# FCA and Surface Water Drainage Strategy - Addendum

**Date:** 19 July 2023

**Project No.** 410.V05415.00009

**RE: Kronospan Lorry Park and Access Road  
Revised Design and Stakeholder Response to Flood Consequence  
Assessment**

## **Appendix A: Surface Water Drainage Strategy Plan**

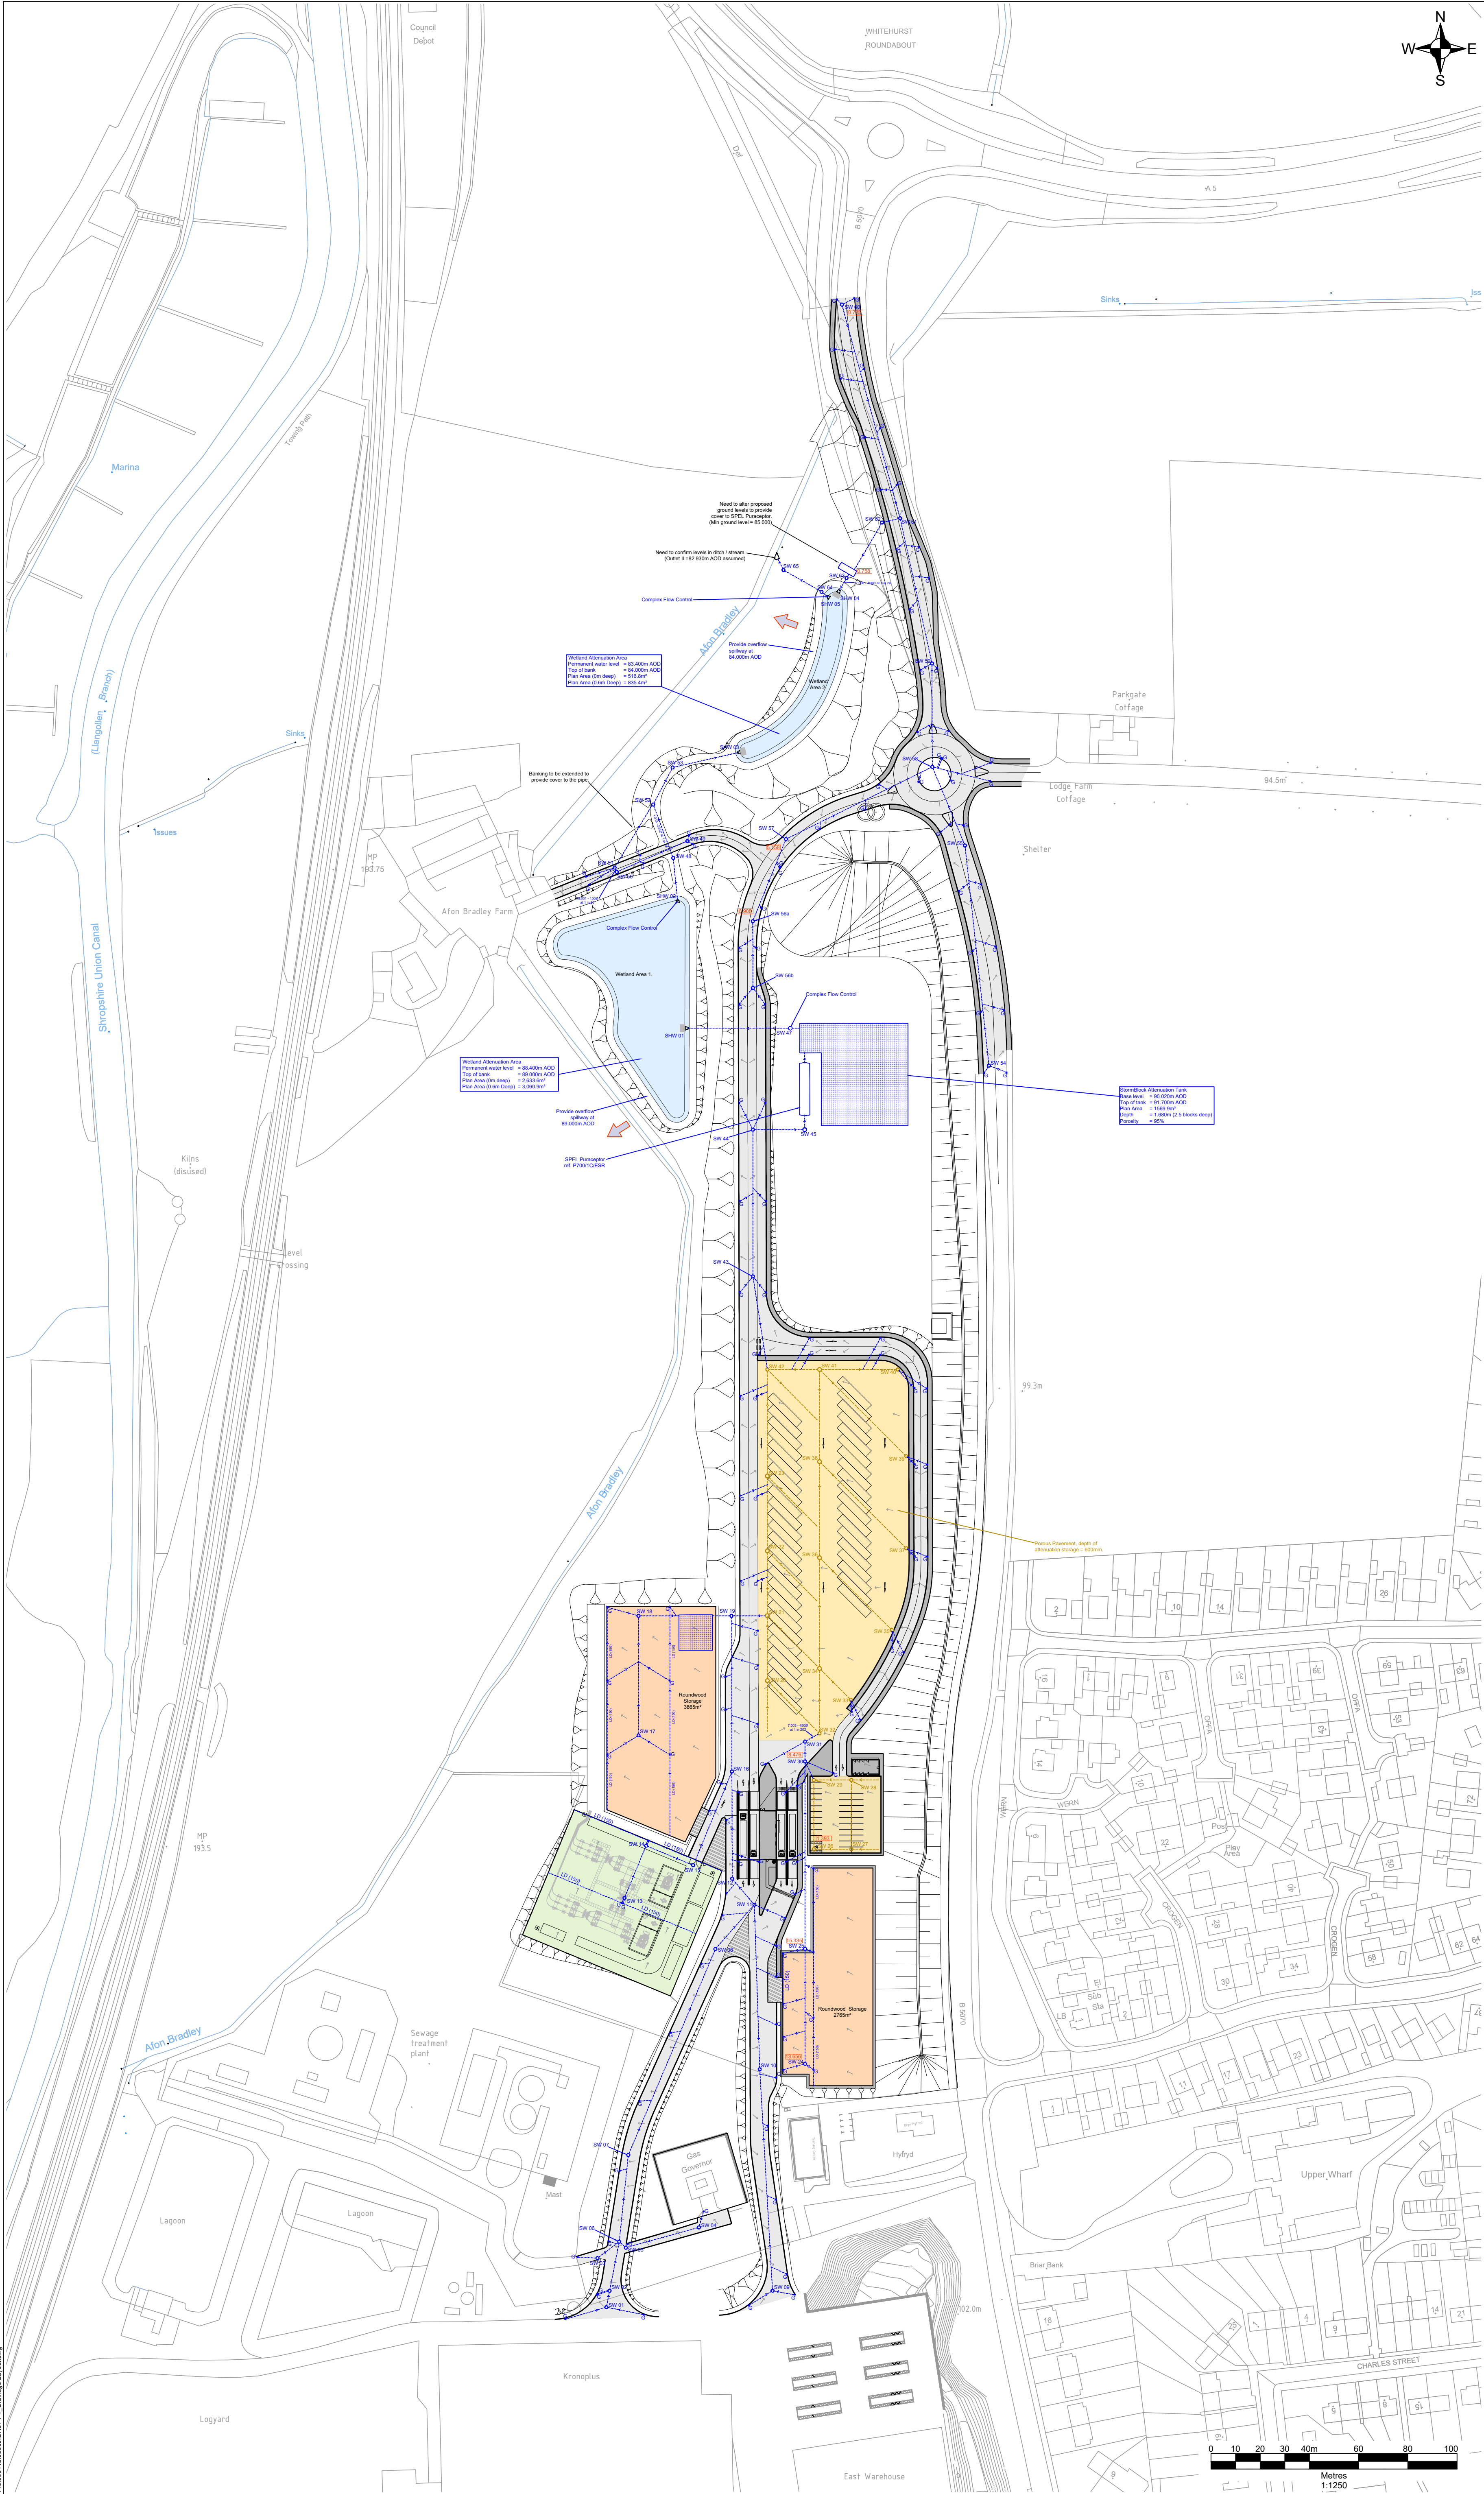
A revision to the surface water drainage strategy has been prepared to reflect the reduction in area for the lorry park. It should be noted that there has been no reduction in the proposed attenuation within the surface water drainage strategy and as such the design is considered conservative with regard to the control of runoff volumes. A copy of the revised surface water drainage strategy plan is included at Appendix A.

NRW have raised concerns over the potential for blockage of this piped drainage connection between the two wetland areas and the potential for this to affect downgradient areas such as Afon Bradley Farm. The revised drainage design includes a designated high level overflow point from the southern wetland area along the western embankment, adjacent to the Afon Bradley. This overflow will ensure any blockage of flows at the culvert to the northern wetland would route into the river. This routing mimics existing local hydrology and will not increase flood risk off site, including at the Afon Bradley Farm.
